REQUEST FOR INFORMATION	DATE: February 21, 2017	NO.: RFI-453
--------------------------------	--------------------------------	---------------------

Project Name:	15051-Webster University Interdisciplinary Science Building	Project No.: 15051
---------------	---	--------------------

Subject: Brick ledge at northwest corner

REQUEST FOR INFORMATION DATE: September 20, 2016 NO.: RFI-290

WEST ELEVATION

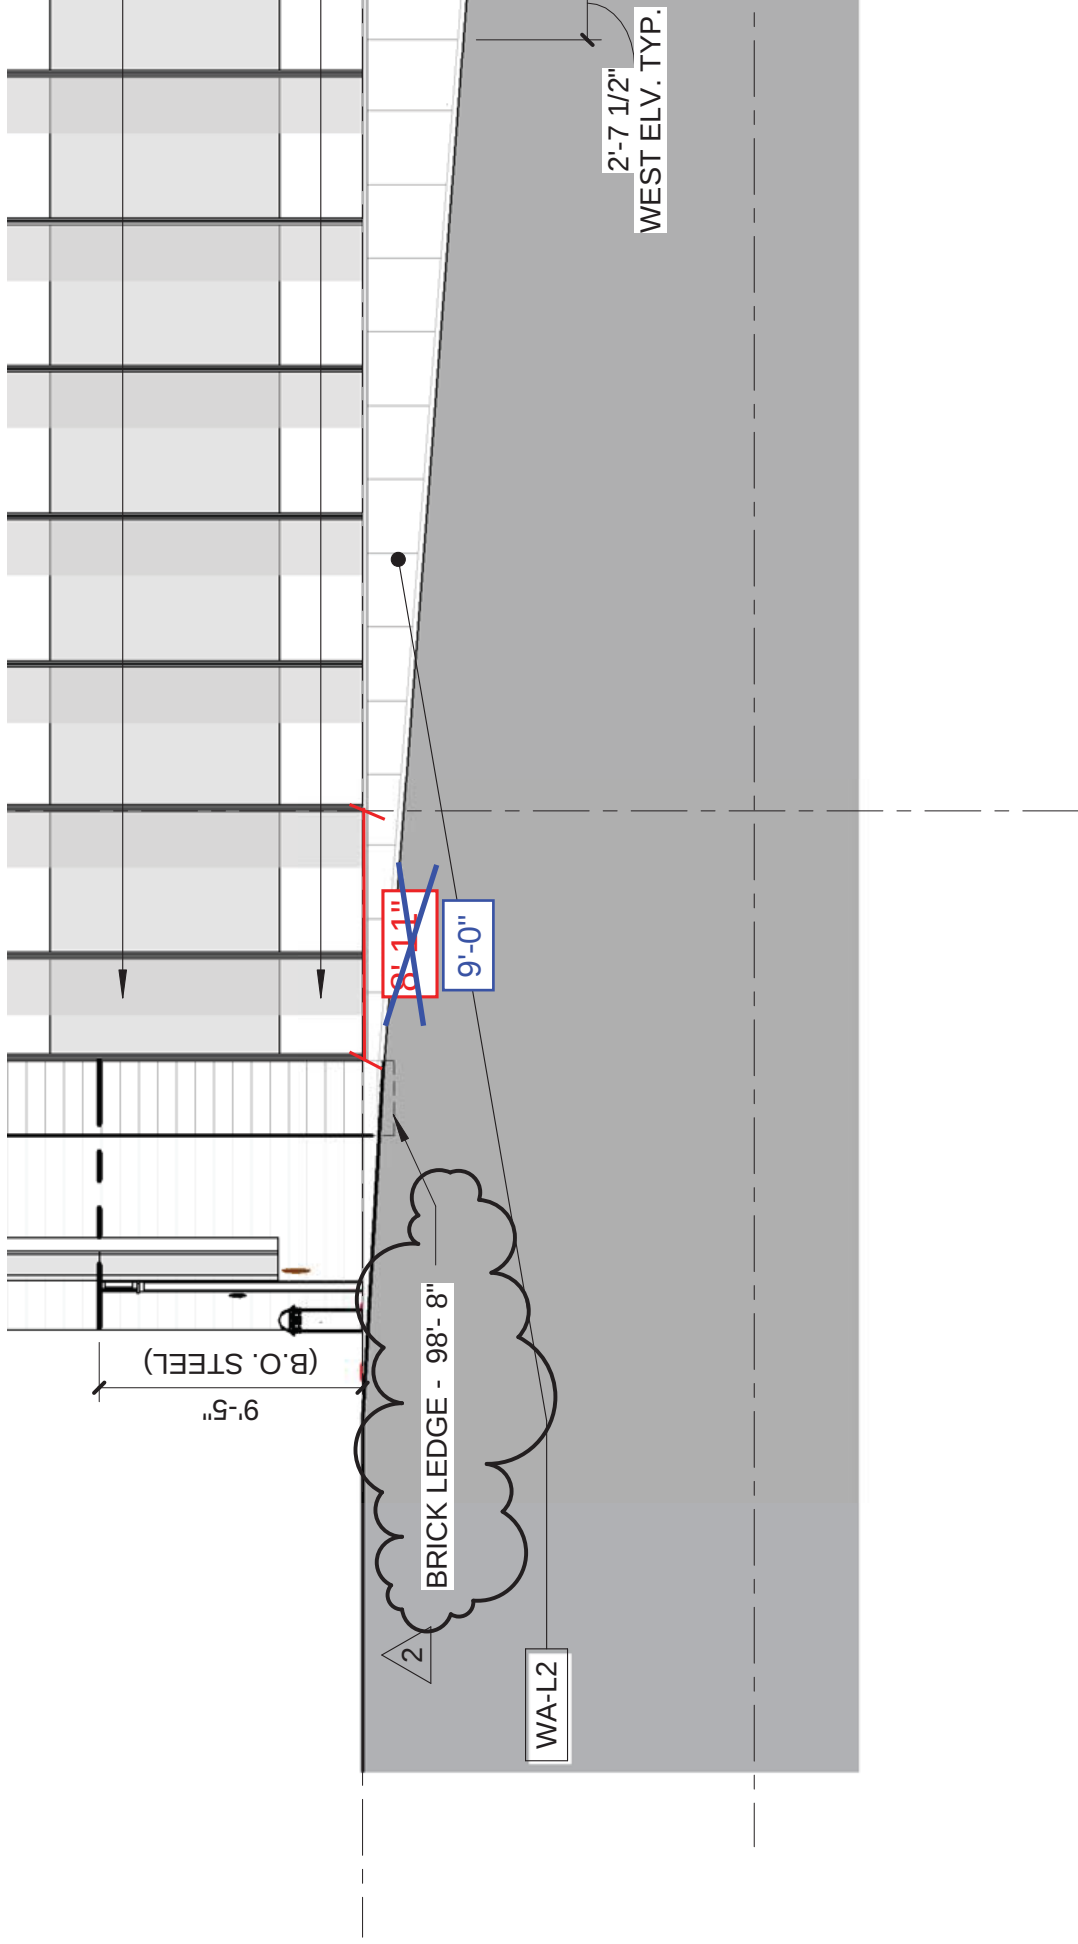
Please confirm the brick ledge shown on the west view of A0311 is to begin 8' 11" west of F line (see attached sketch)

Brick ledge should be 9'-0" west of column line F.
